SUBJECT: ISSUANCE OF AMENDMENTS - JOSEPH M. FARLEY NUCLEAR PLANT,  
 UNITS 1 AND 2 (TAC NOS. MA5119 AND MA5120)

The Nuclear Regulatory Commission (NRC) has issued the enclosed Amendment No. 142 to Facility Operating License No. NPF-2 and Amendment No. 134 to Facility Operating License No. NPF-8 for the Joseph M. Farley Nuclear Plant (Farley), Units 1 and 2. The amendments change the Technical Specifications (TS) in response to your submittal dated April 2, 1999.

SAFETY EVALUATION BY THE OFFICE OF NUCLEAR REACTOR REGULATION  
RELATED TO AMENDMENT NO. 142 TO FACILITY OPERATING LICENSE NO. NPF-2  
AND AMENDMENT NO. 134 TO FACILITY OPERATING LICENSE NO. NPF-8

FIGURE 3.4-1

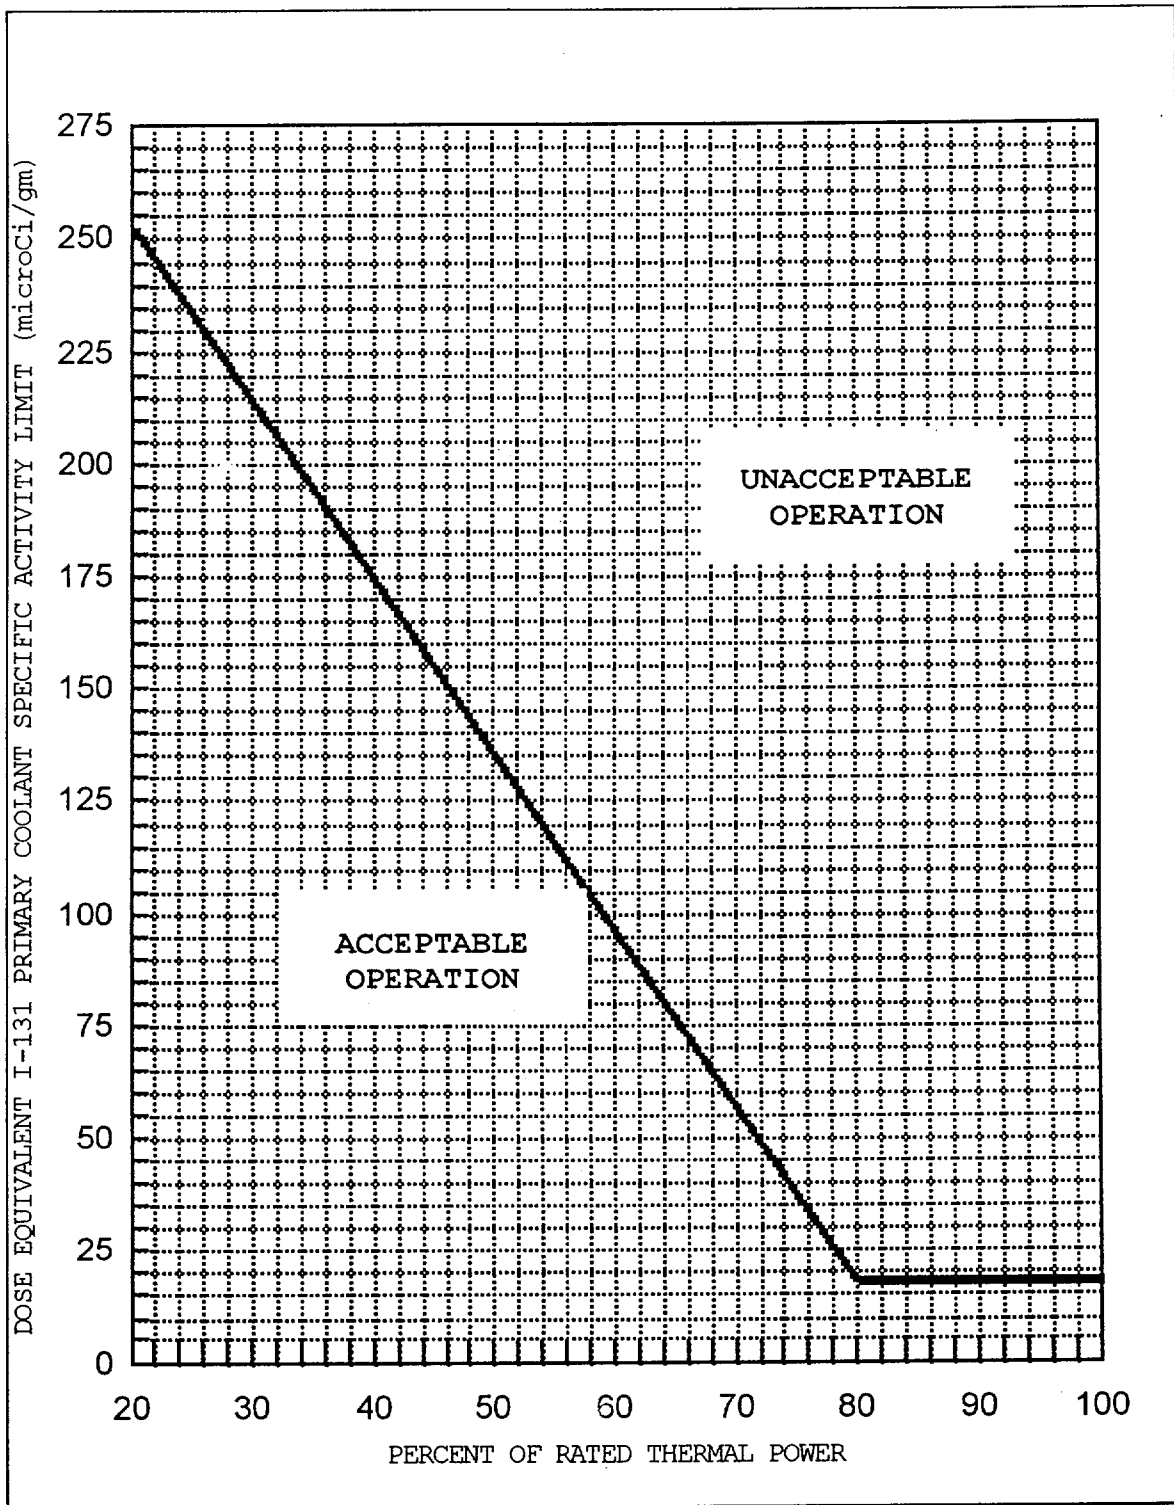
The amendment changes TS 3/4.4.9, "Specific Activity," and the associated bases to increase the limit associated with dose equivalent iodine-131. The steady-state dose equivalent iodine-131 limit would be increased from 0.15  $\mu$ Curie/gram to 0.3  $\mu$ Curie/gram and the transient limit for 80 percent to 100 percent power provided by Technical Specification Figure 3.4-1 will increase from 9  $\mu$ Curie/gram to 18  $\mu$ Curie/gram with a corresponding increase in the 0 percent to 80 percent power limits.

- a. With the specific activity of the primary coolant greater than 0.30 microCurie per gram DOSE EQUIVALENT I-131 for more than 48 hours during one continuous time interval or exceeding the limit line shown on Figure 3.4-1, be in at least HOT STANDBY with  $T_{avg}$  less than 500°F within 6 hours.
- b. With the specific activity of the primary coolant greater than  $100/\bar{E}$  microCurie per gram, be in at least HOT STANDBY with  $T_{avg}$  less than 500°F within 6 hours.

DOSE EQUIVALENT I-131 Primary Coolant Specific Activity Limit Versus Percent of RATED THERMAL POWER with the Primary Coolant Specific Activity > 0.30  $\mu$ Ci/gram Dose Equivalent I-131

The ACTION statement permitting POWER OPERATION to continue for limited time periods with the primary coolant's specific activity greater than 0.30 microCuries/gram DOSE EQUIVALENT I-131, but within the allowable limit shown on Figure 3.4-1, accommodates possible iodine spiking phenomenon which may occur following changes in THERMAL POWER.

FIGURE 3.4-1

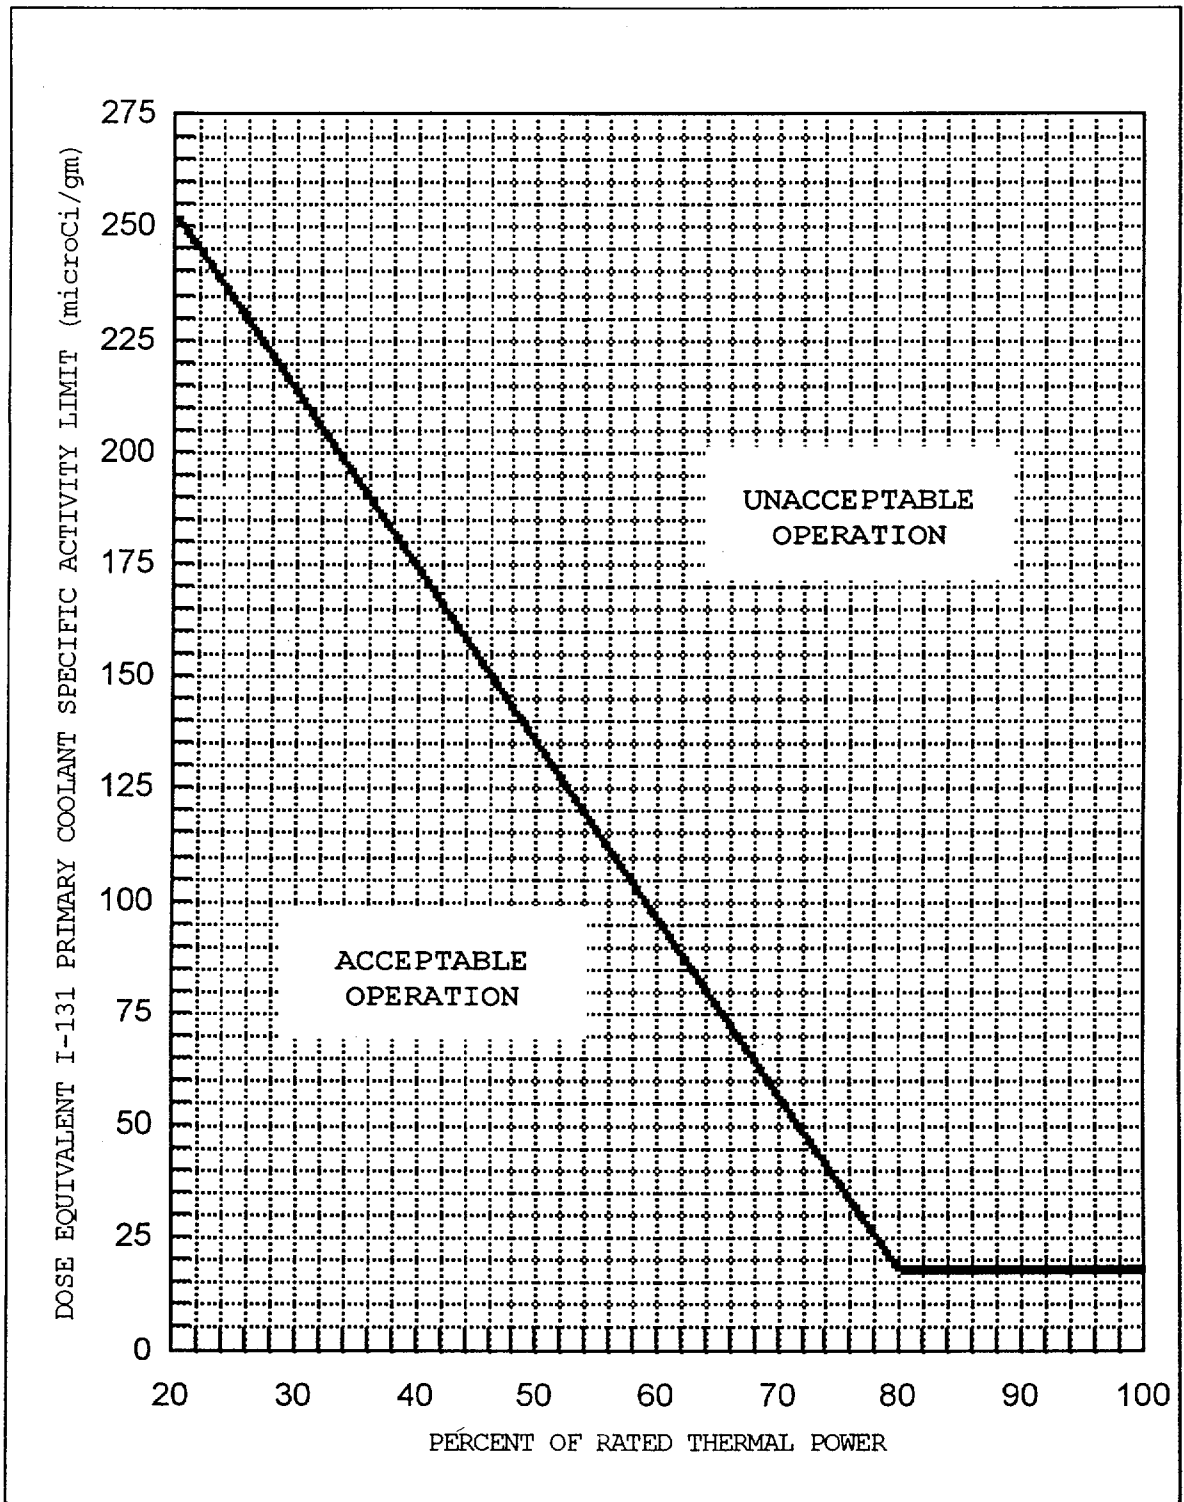
- a. With the specific activity of the primary coolant greater than 0.30 microCurie per gram DOSE EQUIVALENT I-131 for more than 48 hours during one continuous time interval or exceeding the limit shown on Figure 3.4-1, be in at least HOT STANDBY with  $T_{avg}$  less than 500°F within 6 hours.
- b. With the specific activity of the primary coolant greater than  $100/\bar{E}$  microCurie per gram, be in at least HOT STANDBY with  $T_{avg}$  less than 500°F within 6 hours.

DOSE EQUIVALENT I-131 Primary Coolant Specific Activity Limit Versus Percent of RATED THERMAL POWER with the Primary Coolant Specific Activity > 0.30  $\mu\text{Ci}/\text{gram}$  Dose Equivalent I-131

The ACTION statement permitting POWER OPERATION to continue for limited time periods with the primary coolant's specific activity greater than 0.30 microCuries/gram DOSE EQUIVALENT I-131, but within the allowable limit shown on Figure 3.4-1, accommodates possible iodine spiking phenomenon which may occur following changes in THERMAL POWER.
